City of Portland, Maine - Building or Use Permit Application
389 Congress Street, 04101 Tel: (207) 874-8703, Fax: (207) 874-8716

Permit No: 01-04784Y	Issue Date: 11 2001	CBL: 248 B015001
-------------------------	------------------------	---------------------

Past Use: Single Family	Proposed Use: Single Family / Garage with family room on existing foundation; 24' x 24'7" garage & 16'4" x 13'9" family room. **Call Donald Apon 774-3216.	Permit Fee: \$264.00	Cost of Work: \$40,000.00	CEO District: 3
Proposed Project Description: Build Garage & Family Room		FIRE DEPT: <input type="checkbox"/> Approved <input type="checkbox"/> Denied	INSPECTION: Use Group: R-3 Type: 5B

REASON FOR PERMIT: To Construct Private garage & Family Room

R-I zone

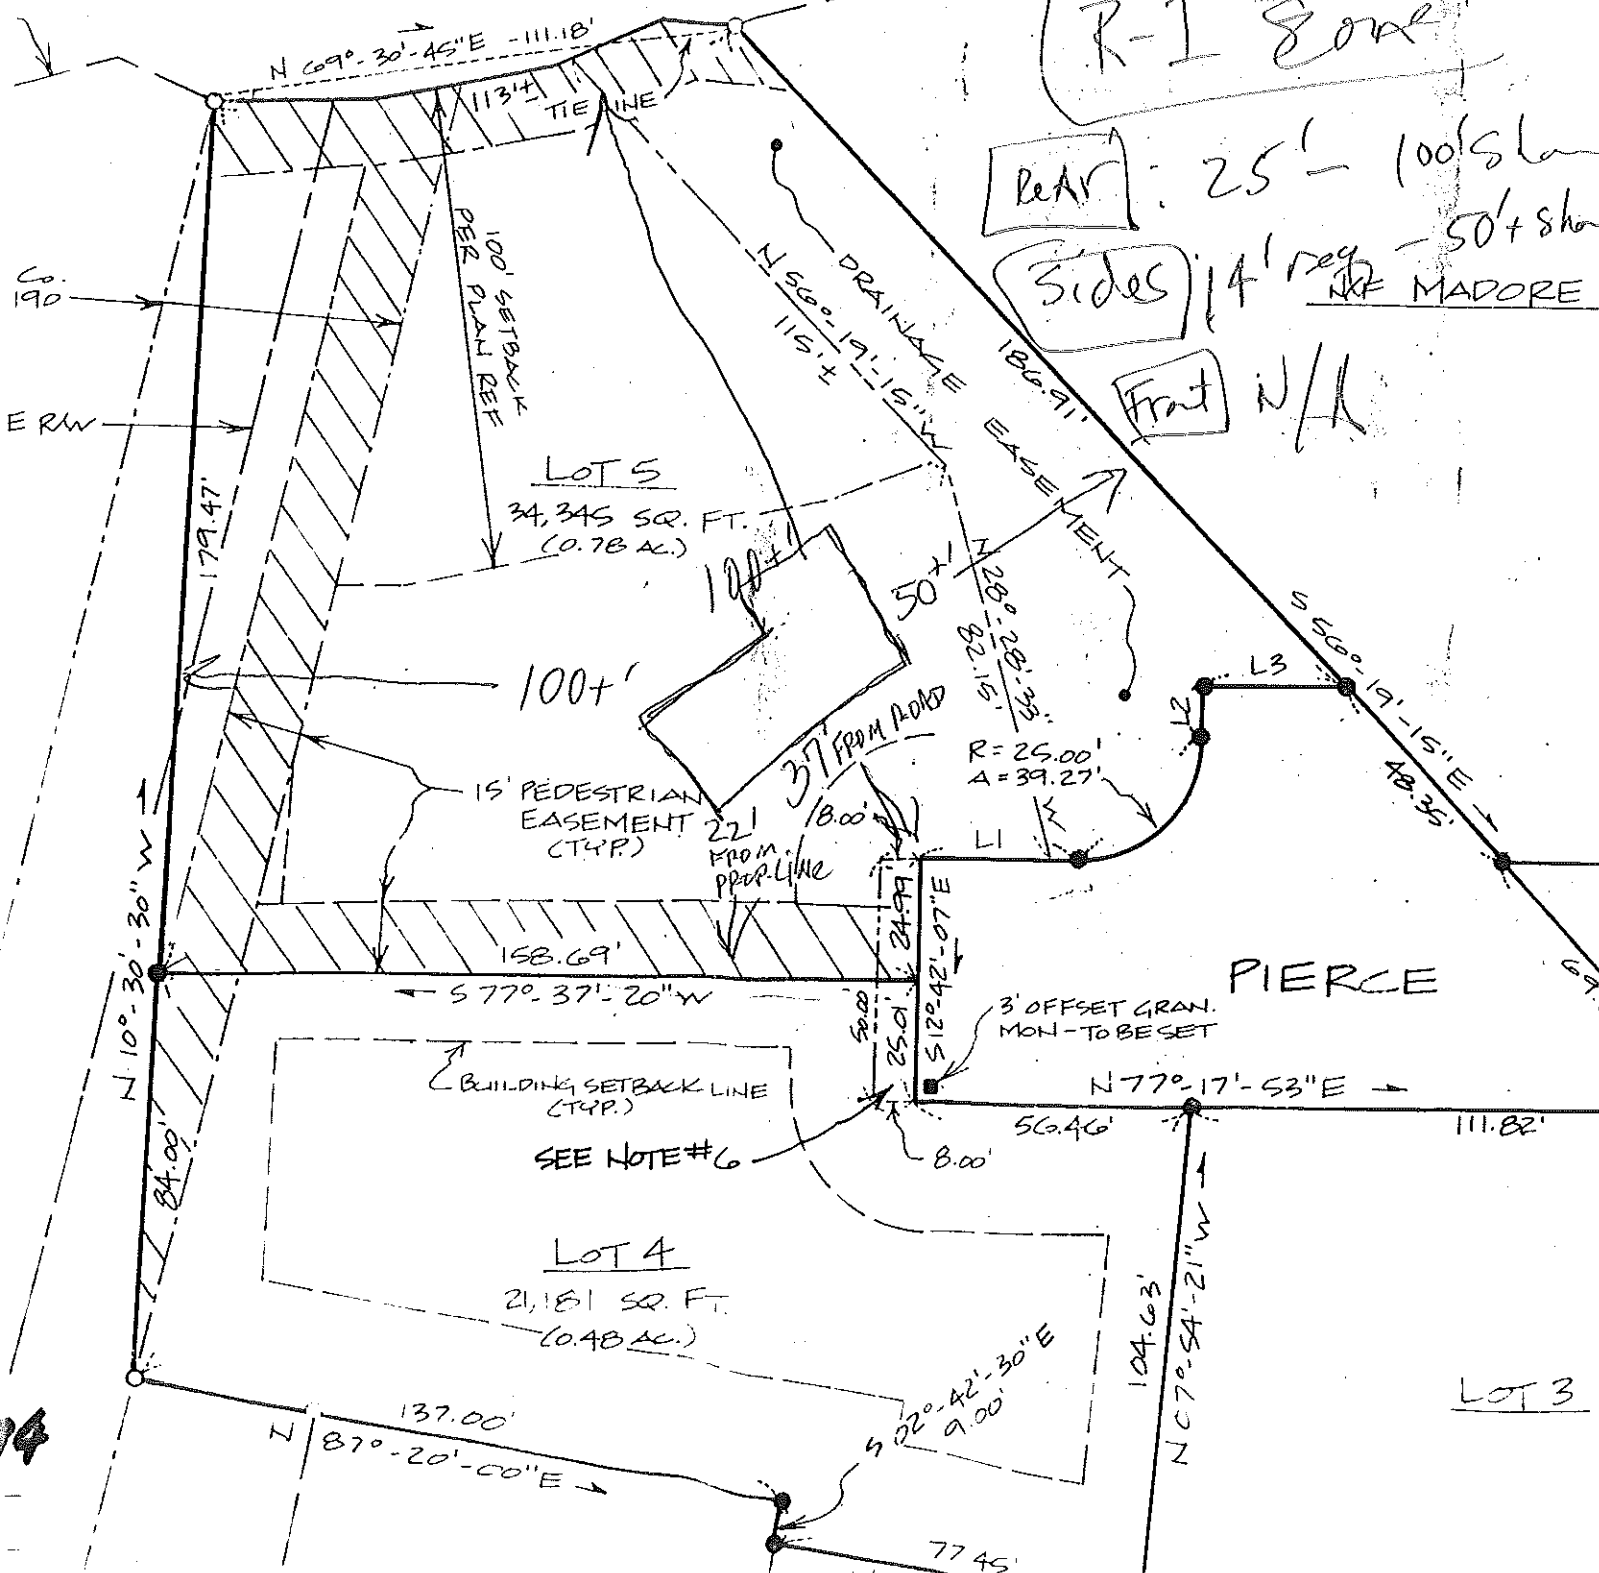
REAR: 25' - 100' sh
Sides 14' req - 50' sh
N/K MADORE

MOVE DECK AND DOOR
